ALERT SERVICE BULLETIN

CHECKING OF MAGNETIC PLUG

ON ROTAX® ENGINE TYPE 912/914 (SERIES)

ASB-912-051

fig. 2

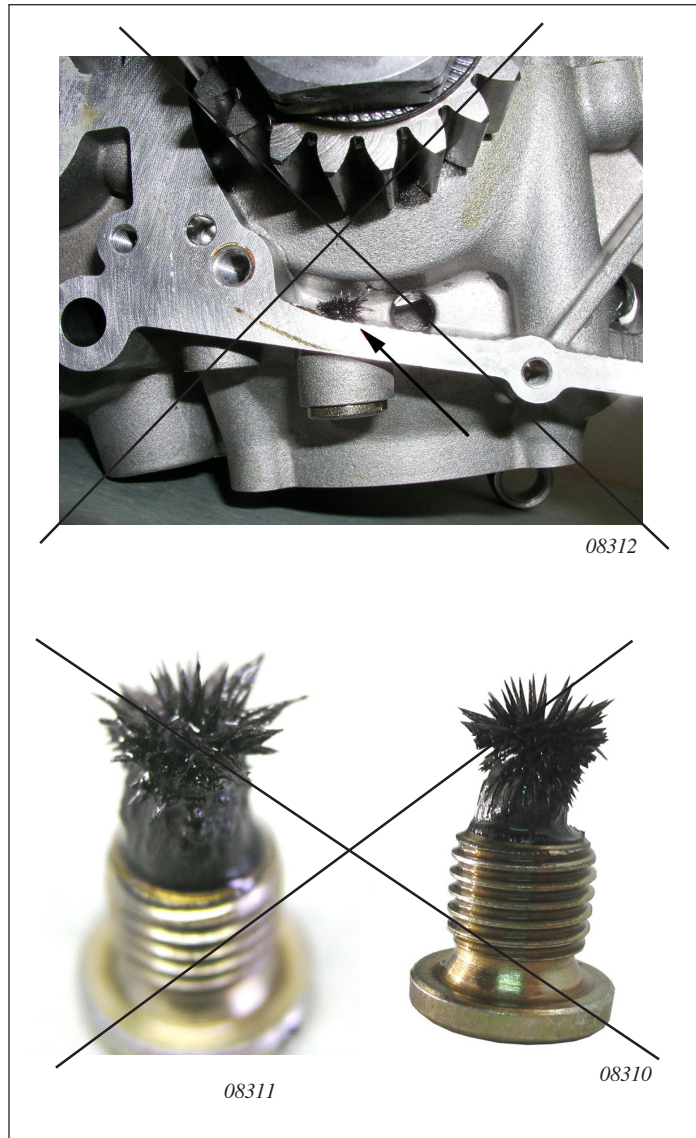
See fig. 1 and fig. 2

- Remove the magnetic plug according to relevant Maintenance Manual.
- Inspect magnetic plug in accordance with procedure in relevant Maintenance Manual.

■ **CAUTION:** If a greater quantity of metal particles (more than 3 mm (1/8")) is detected, consultation of an authorized distributor regarding further action is necessary. The engine must not be taken into operation until the cause has been identified and eliminated.
